Access Compliance Report

Public Rights-of-Way

(Curb Ramps)

Intersection ID: 9814	Main Street: CLIFTON_ST	Cross Street: PATTON_AV	Location:	N
ADA ID: A0C411A5351F	Ramp Type: Perp	Initial Pass/Fail: Fail	Overall Compliance: No	Severity Score: 8.75
Codes/Mitigation Info/Possible Solution		Field Measurements/Component Compliance

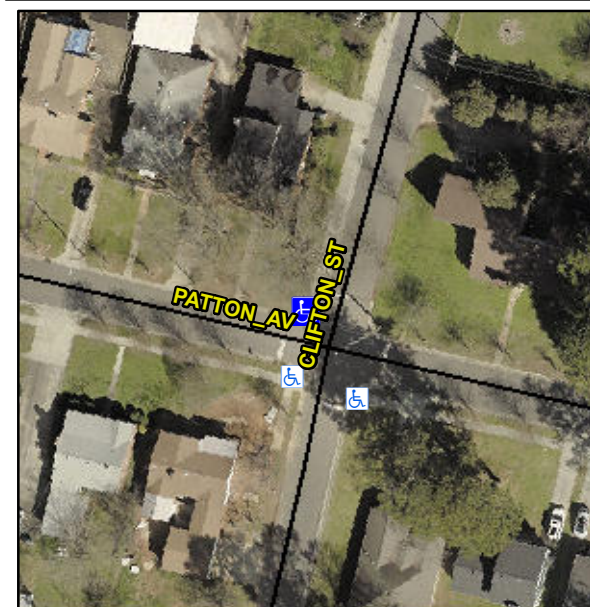
Not Found, R304.5.1

Compliance	Description	Data	Compliance	Description	Data
N/A	Ramp Length (in)	71.5	Yes	Ramp Slope (%)	6.9
No	Ramp Width (in)	46.5	Yes	Ramp XSlope (%)	1.9
N/A	Flare Type LT	N/A	N/A	Flare Type RT	N/A
N/A	Flare Slope LT (%)	N/A	N/A	Flare Slope RT (%)	N/A
N/A	Flare Traversable LT?	N/A	N/A	Flare Traversable RT?	N/A
N/A	Landing Length (in)	N/A	N/A	DWS Provided?	N/A
N/A	Landing Width (in)	N/A	N/A	DWS Contrast?	N/A
N/A	Landing Slope (%)	N/A	N/A	DWS Length (in)	N/A
N/A	Landing X Slope (%)	N/A	N/A	DWS Full Width?	N/A
N/A	Landing Curb? (Y/N)	N/A	N/A	DWS Offset (in)	N/A
N/A	Shared Landing?	N/A			
N/A	Gutter Ponding?	N/A	N/A	Gutter Slope (%)	N/A
N/A	Gutter Lip Ht (in)	N/A	N/A	Gutter X Slope (%)	N/A
N/A	Painted X Walk1?	No	N/A	Painted X Walk2?	N/A
	X Walk 1 Direction	To SW		X Walk 2 Direction	N/A
N/A	X Walk 1 Width (in)	N/A	N/A	X Walk 2 Width (in)	N/A
	X Walk 1 Slope (%)	0.3		X Walk 2 Slope (%)	N/A
	X Walk 1 X Slope (%)	0.5		X Walk 2 X Slope (%)	N/A

Remove & Replace Entire Ramp.
